Our Reference: 191149

26th November 2020

RESPONSE TO FURTHER INFORMATION REQUEST FOR KAPUNI GREEN HYDROGEN PROJECT

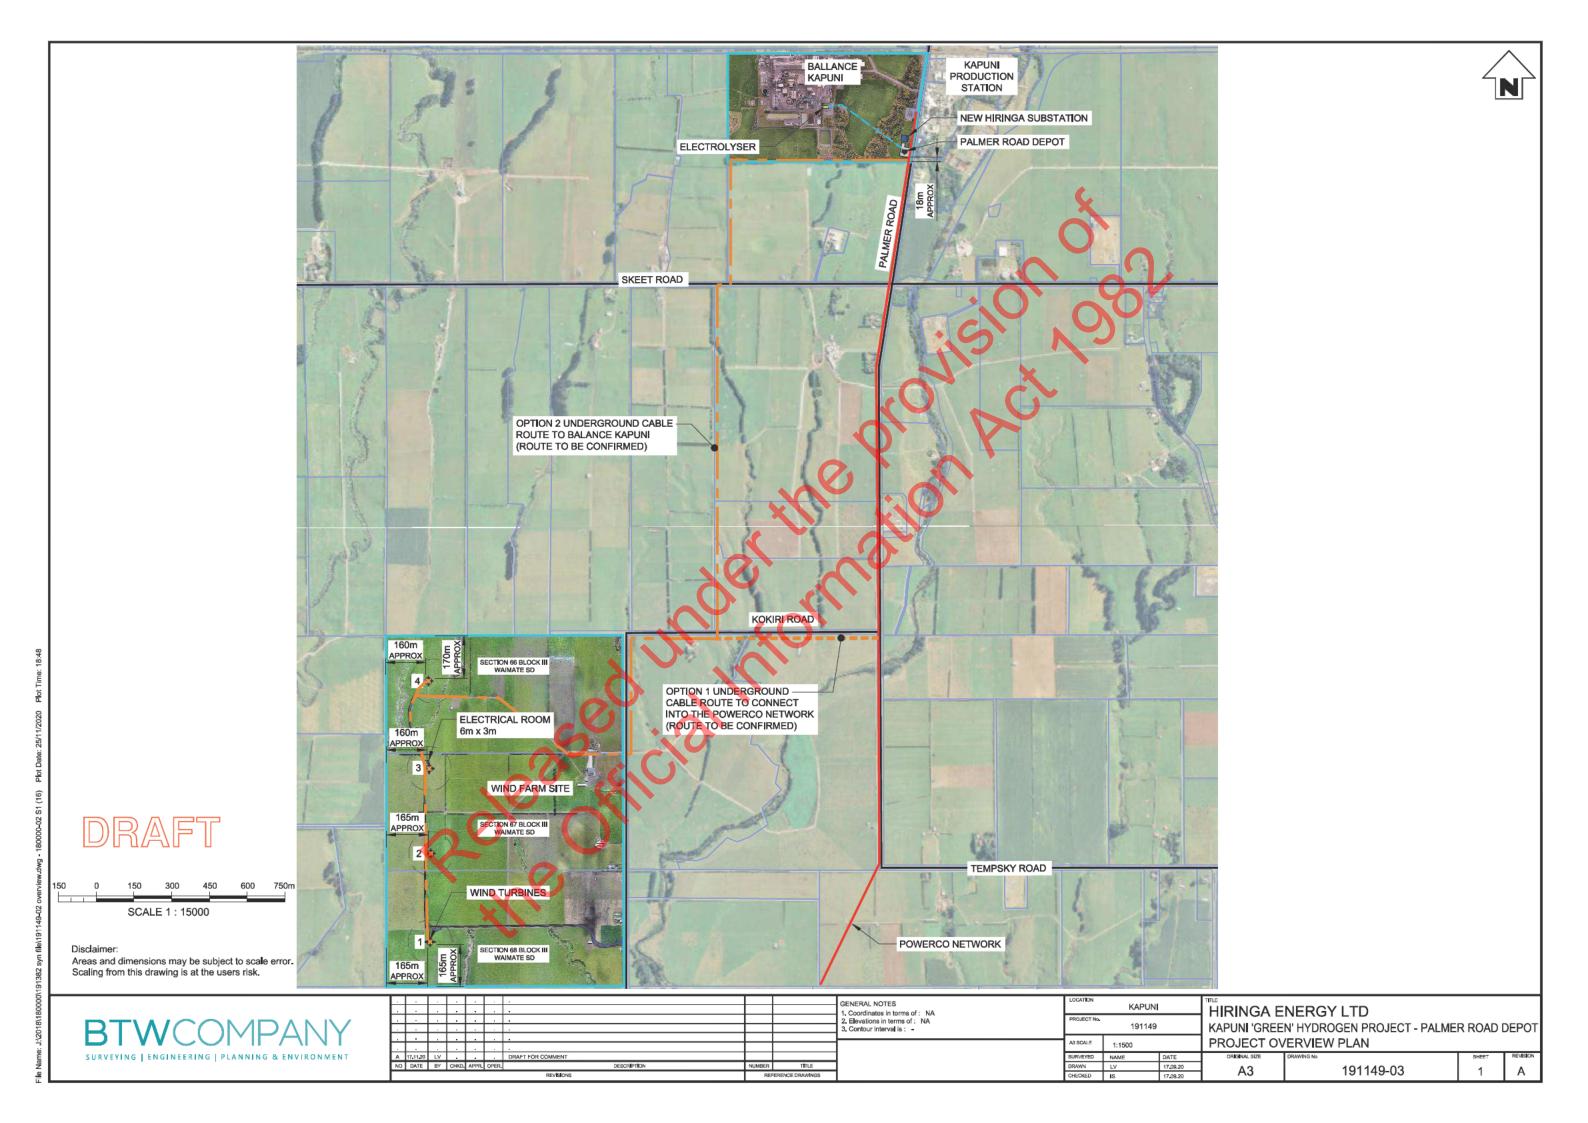
d. The application details that "excess power" is expected to be fed into the grid. Please provide further details (if possible) on the proportion/quantities of electricity that is anticipated to be utilised for urea production vs fuel cells/transport vs exporting to the network.

The first 4.3 MW of electricity generated by the turbines will be used to power the Ballance site. The next tranche of electricity generation above 4.3 MW will nominally be used to produce green hydrogen. The hydrogen electrolysers have a maximum consumption of approximately 7.5 MW of electricity. If enough electricity is generated to supply the Ballance site plus the maximum hydrogen electrolyser demand, a total of 11.9 MW, excess generation will be exported to the grid.

In addition, if the grid demand is high, the generated electricity may be exported to the grid in preference to hydrogen production from time to time.

The graph below shows the estimated generation and percentage of time each service will be supplied from the wind farm.

For the 4 x 6MW turbine case, the Annual Energy Production generated from the wind turbines is forecast to be 102GWhr with power consumption split between:

- 28.6% will be supplied to Ballance
- 38.7% for hydrogen production; and
- 32.7% exported to the Grid.

APPENDIX B SITE LAYOUT PLANS

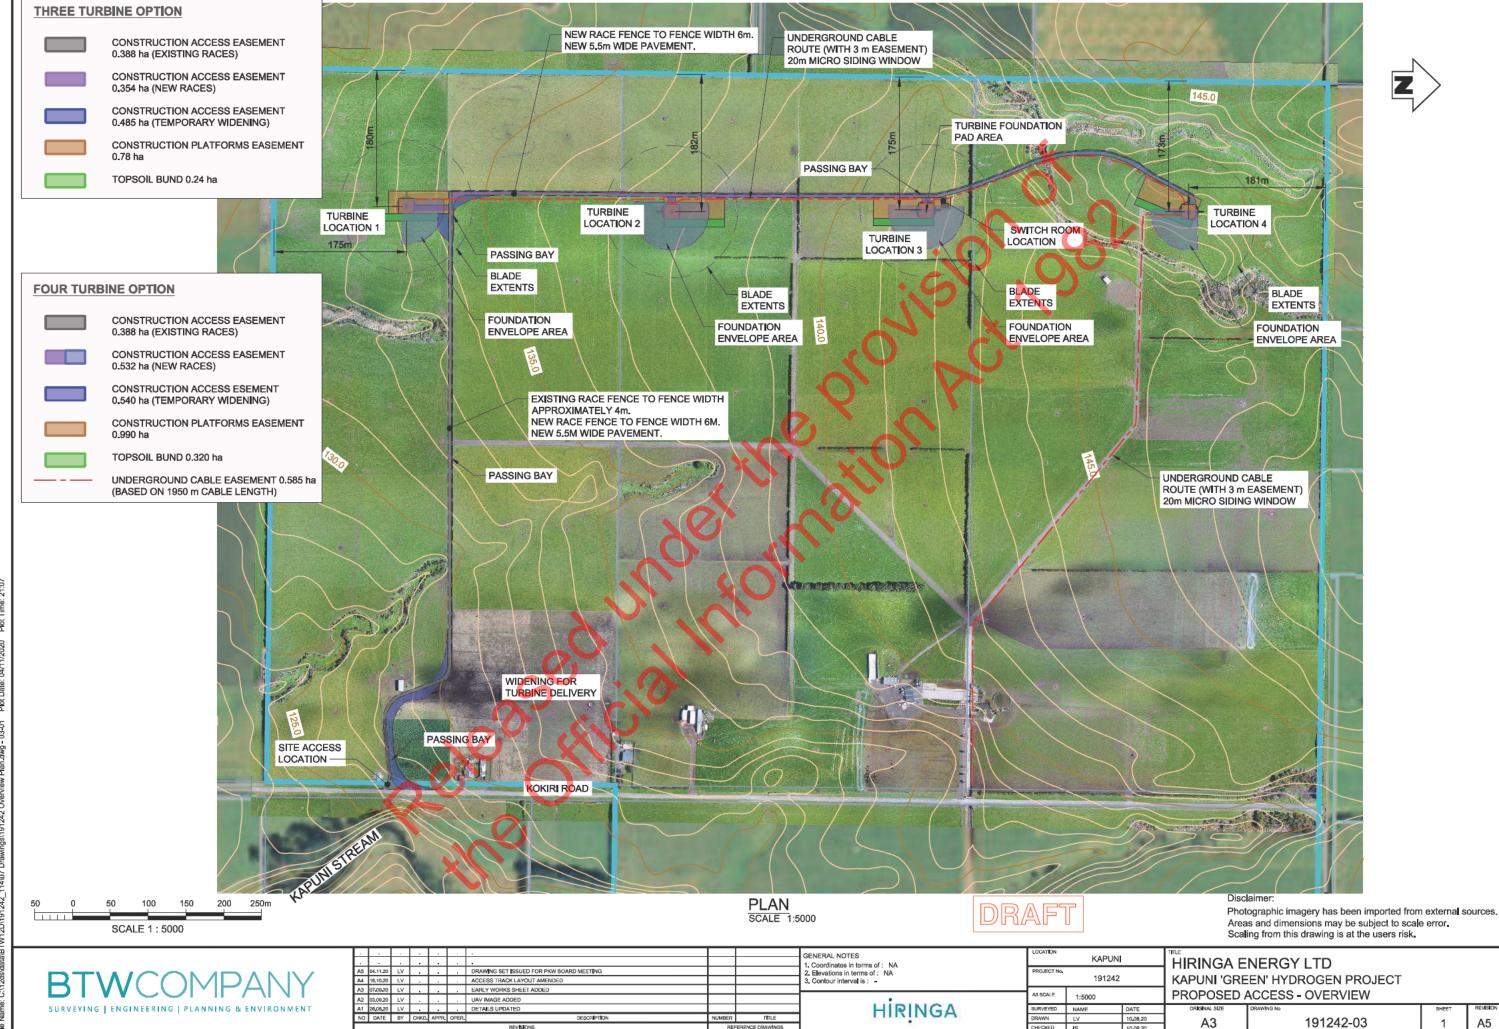
- Site plans (concept is acceptable at this stage) of each site where physical works/development is proposed clearly showing the proposed location of key components involved in the project, e.g. access points, proposed buildings and structures, load-out facilities, other physical works.

A locality plan is attached as **Appendix A** and a site layout plan for the PKW farm and for the Ballance Kapuni Plant showing the key components of the project is attached as **Appendix B**. An plan showing the turbine dimensions is attached as **Appendix C**.
